Noncompliant Weld Inspection Techniques

Line 114 Non Destructive Examination Final Report

Issue Date December 5, 2013

Figure 2 - Weld 270 Indication with measurement inset showing length of 0.157" (3.9mm)

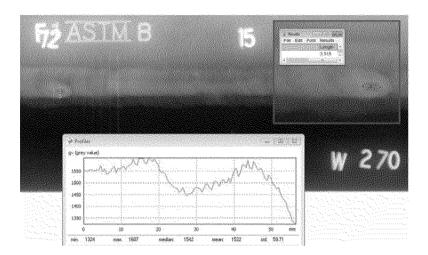
3.1 Weld 270, digitized in the region of interest is depicted in Figure 2. Here it can be seen, due to low change in density which is less than the adjacent parent material, and the presence of a halo, that the indication is one of Burn-Through (BT), and is acceptable per section 9.3.7 of API-1104. The weld repair process confirmed this result where the indication was found at the root.

Figure 3 – Weld 311 with acceptable BT length of 0.141" and acceptable small pores

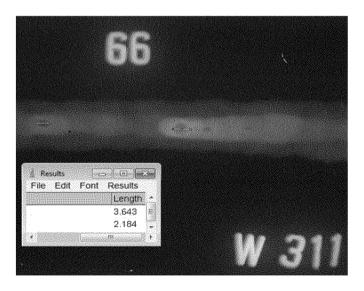
3.2 Weld 311, digitized in the region of interest, is depicted in Figure 3. Similarly we have one indication of burn-through and 3 small pores, all of which are acceptable per sections 9.3.7 & 9.3.9 of API 1104. For both welds 270 and 311, the repair process had to proceed to the root before the indications were eliminated, confirming that they were caused by burn through.

Figure 4 – Weld 162 with acceptable indications of undercut

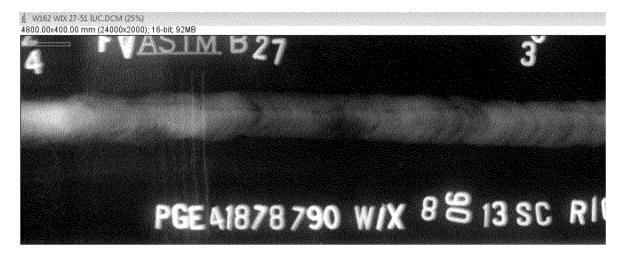
3.3 Weld 162 indication was digitized as shown below in Figure 4. Radiographic density measurements indicate that no portion of the indication has an indication of undercut which is greater than 0.016" deep, indicating that it is acceptable per section 9.3.11& 9.3.7 of API 1104.

Figure 5 - Measured IUC on W162 depicted in Figure 4

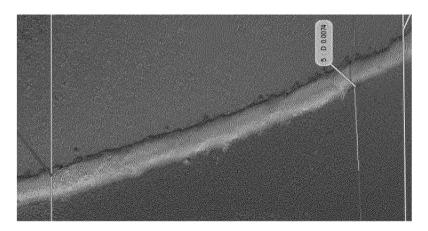
- 3.4 To validate the digital radiographic measurements, external visual, UC gaging and dial indicator measurements revealed that only small areas within the called ROI (25-29) had bottoms estimated below the adjacent parent material surface. Measurements had thus low repeatability due to topography. This result led to the decision for the Creaform photogrammetry with its calibrated 40 micron spatial resolution and accuracy to within 0.002".
- 3.5 Creaform photogrammetry results were obtained for the radiographic ROI (25-29 in Figure 4). The measurements confirm that no portion of the indicated area of concern radiographically, has a depth greater than 0.016 inches, and is therefore acceptable per sections 9.3.11 & 9.7. Figure 5 below depicts worst case of 0.0074" in radiographic ROI.

Figure 1 – Assessment of Weld 760 IUC region of interest

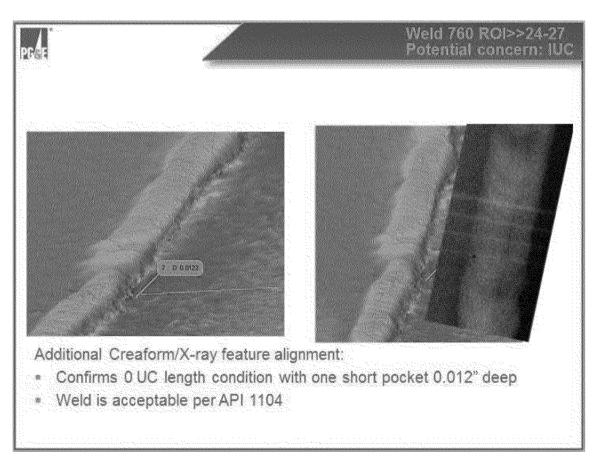
3.5 Creaform photogrammetry results were obtained for all the radiographic ROI's. The criteria applied to these results were API 1104 section 9.7, Table 4, "Maximum Dimensions of Undercutting". Applying the further criteria of depth from this requirement, to the documented radiographic and visual measurement data for length, all welds were found acceptable. Figure 2, from slide 5 in Appendix I, summarizes the typical physical condition for the audit identified indications of concern.

Weld 760 cited for indications of internal undercut from 24-27
Excised weld photo-documented and ROI aligned with weld features
Depth of most severe indications estimated by change in x-ray density

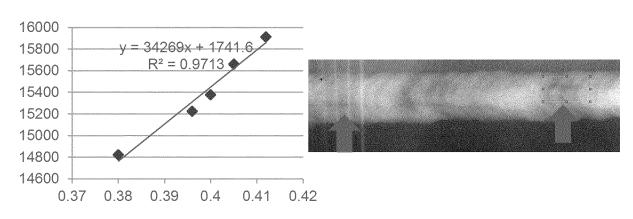
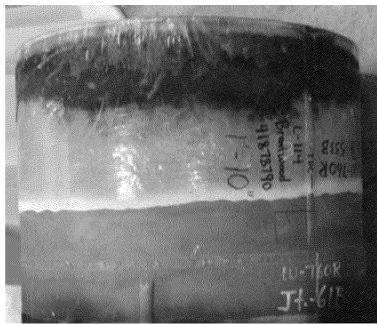
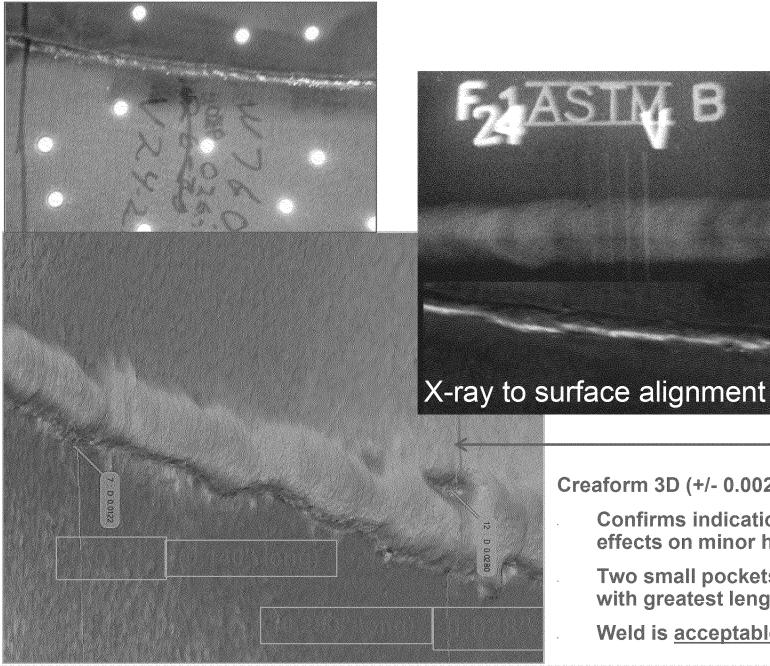
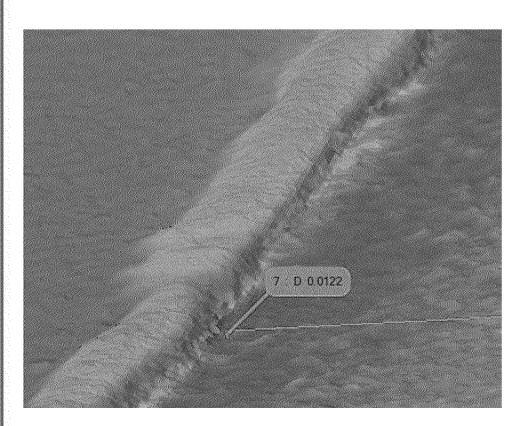
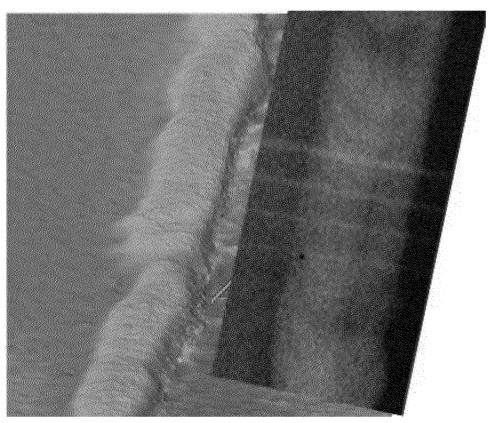
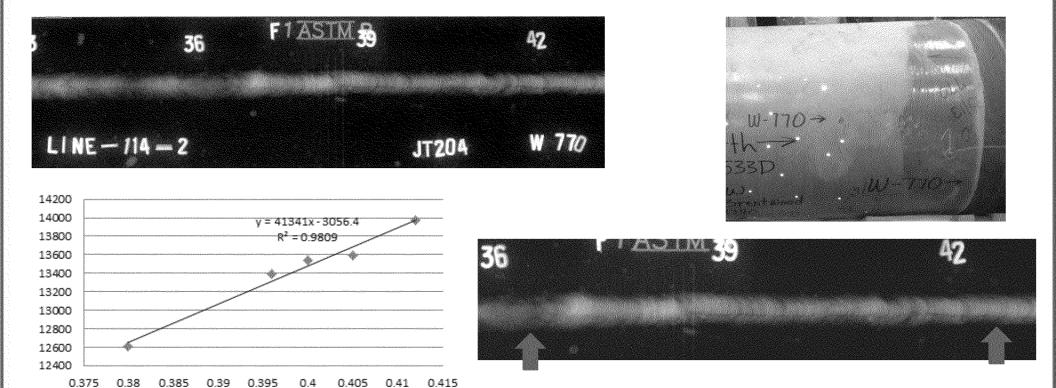
- **Confirms indications are mostly diffraction** effects on minor hi/lo condition with 0 UC
- Two small pockets are 12 and 28 mils deep with greatest length of 0.250"
- Weld is acceptable per API 1104

- * Confirms 0 UC length condition with one short pocket 0.012" deep
- * Weld is acceptable per API 1104

Weld 771 cited for indications of internal undercut from 12-24

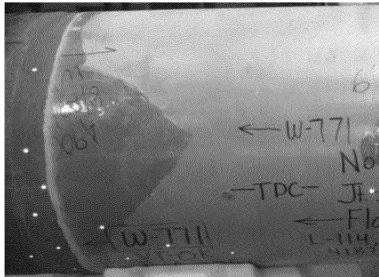
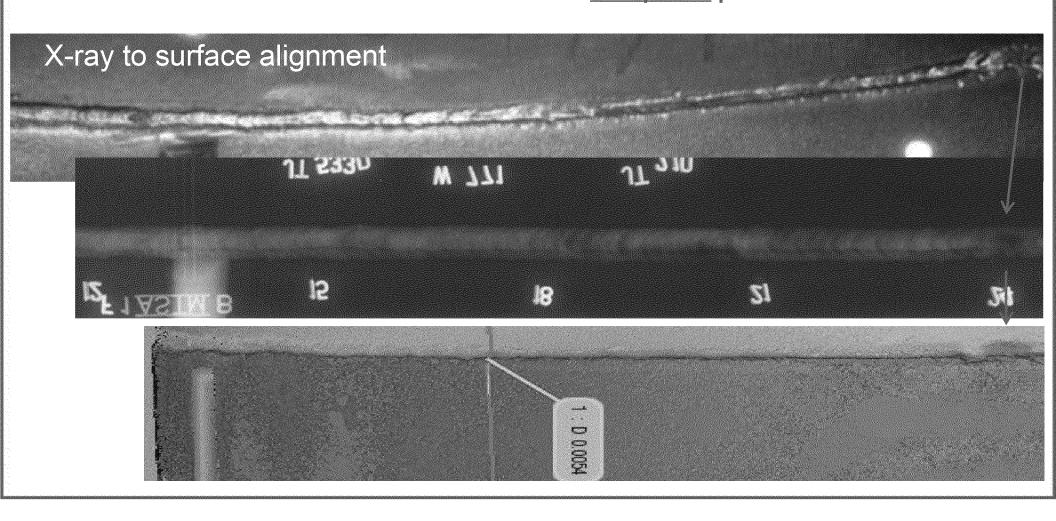
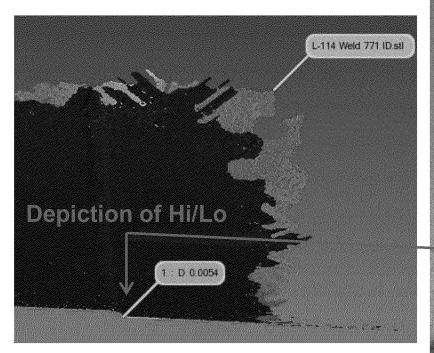
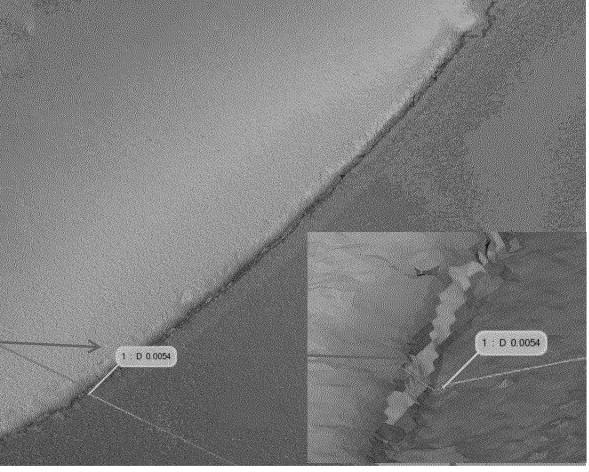
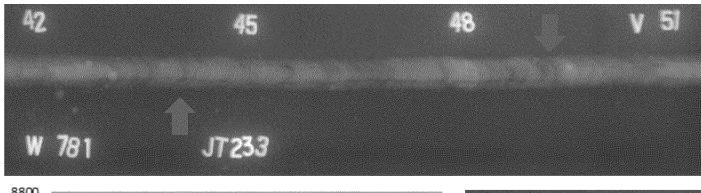
Depth of most severe indications estimated by change in x-ray density

Confirms indications are mostly diffraction effects on minor hi/lo condition with 0 UC

Deepest region along length is 0.006 inches

Weld is acceptable per API 1104

- * Confirms UC indication is diffraction/"shadowing" from high/low condition
- * Weld is acceptable per API 1104

Weld 781 cited for indications of internal undercut from 44-49

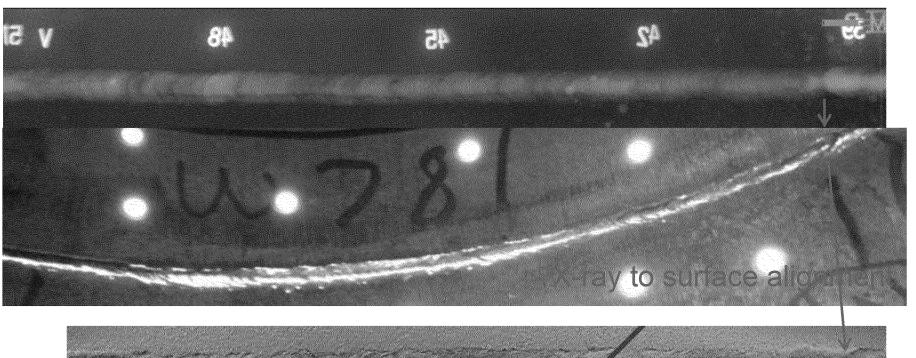
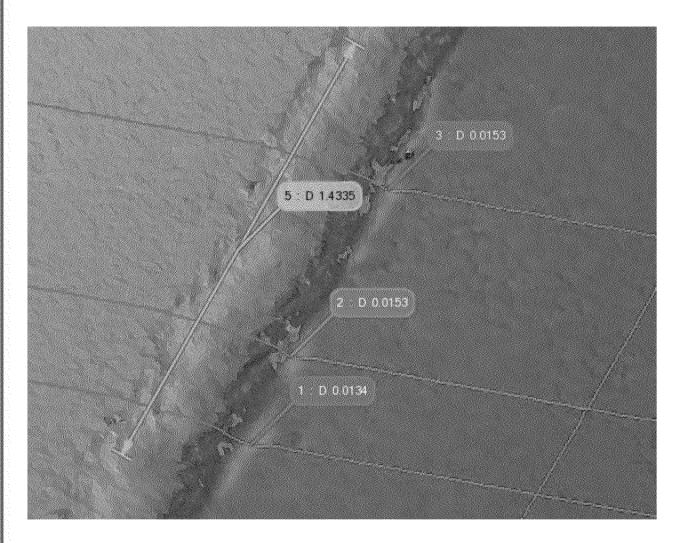
Confirms indications are mostly diffraction effects on minor hi/lo condition with 0 UC

Largest region is 1.5 long x up to 0.015 inches deep

- * Confirms UC indication is, in the majority, diffraction/"shadowing" from high/low condition with less than 2 inches of up to 0.015 inches deep IUC
- * Weld is acceptable per API 1104

Weld 738 cited for indications of external undercut from 36-42
Excised weld photo-documented and ROI aligned with weld features
Depth of most severe indications estimated by change in x-ray density

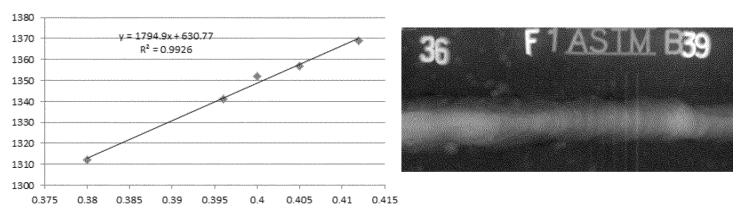
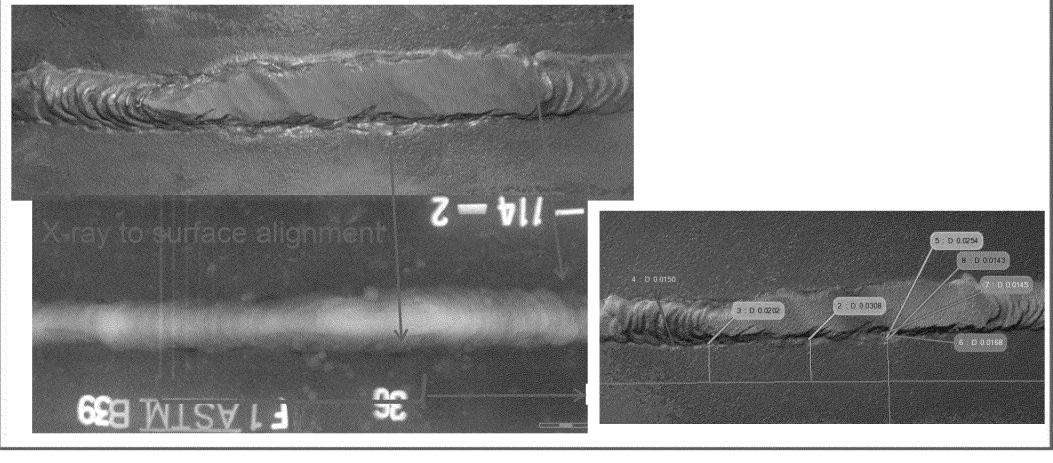
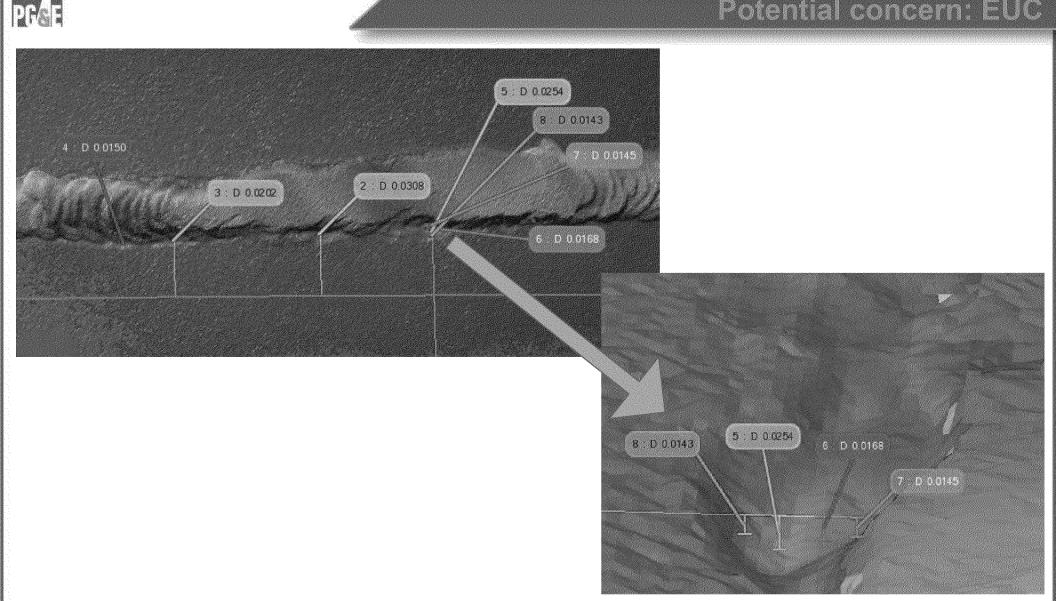
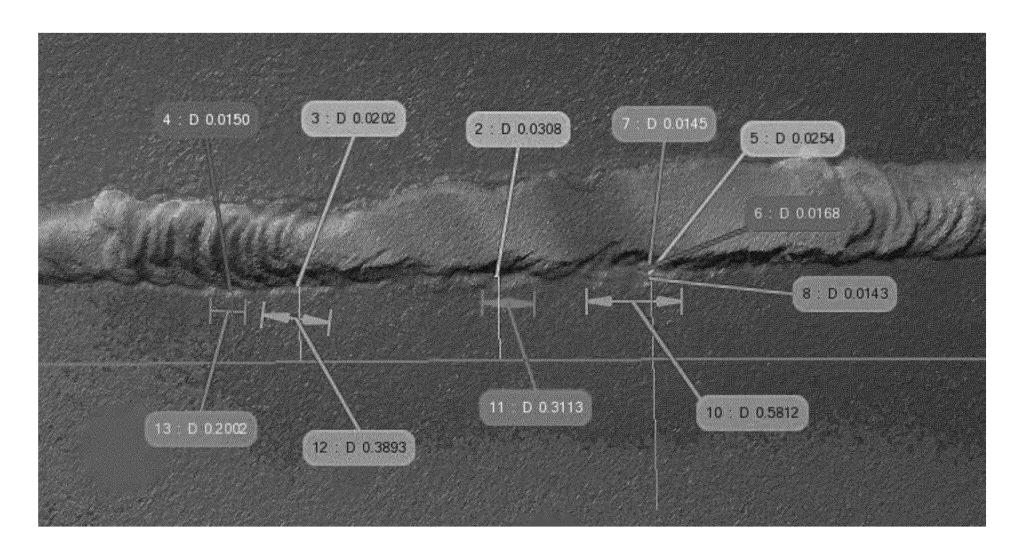
RT <u>estimated</u> depths of up to 0.030 inches Further correlation pursued with 3D surface map

- External undercut identified up to 0.030" deep
- Sum of UC lengths < 1.5"
- Weld is acceptable per API 1104

- * EUC noted in several short segments totaling less than 1.5"
- * Weld is acceptable per API 1104
